PRODUCT CHANGE NOTIFICATION

E-Switch Series/ Part No affected: TL3253 series (all P/Ns)

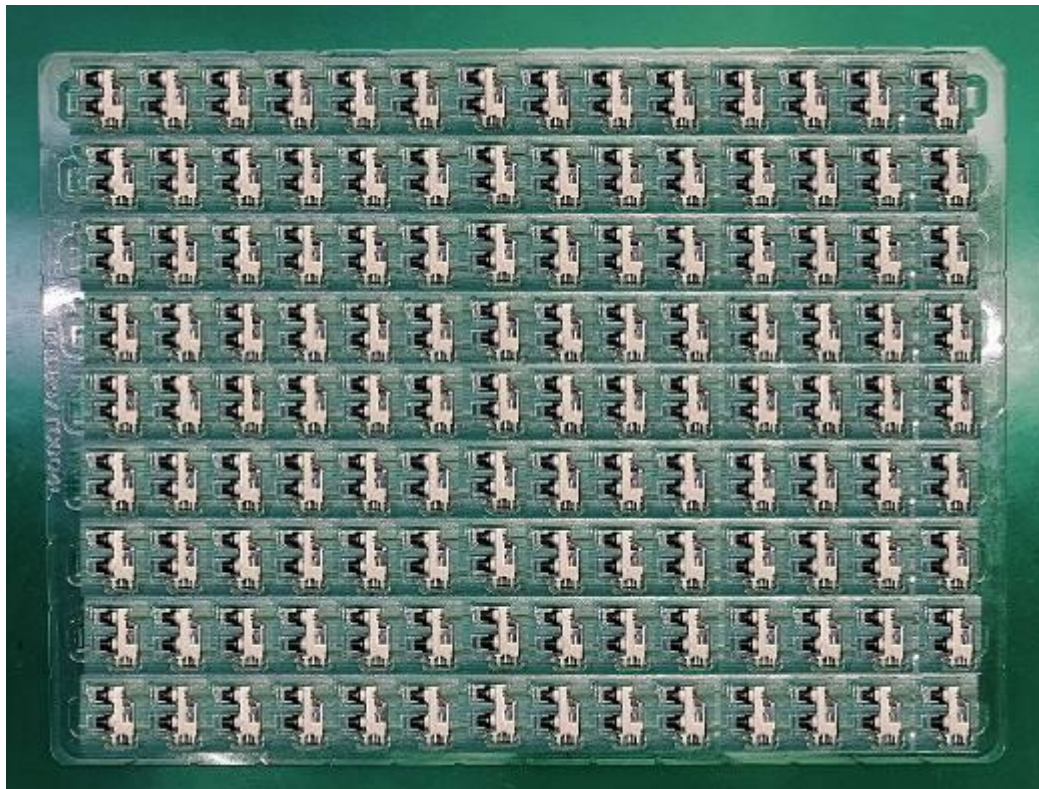
1. Improve packaging to prevent switch terminals from damage during shipping.
2. Package 1 piece per cavity instead of 2. New quantity per tray is 126.
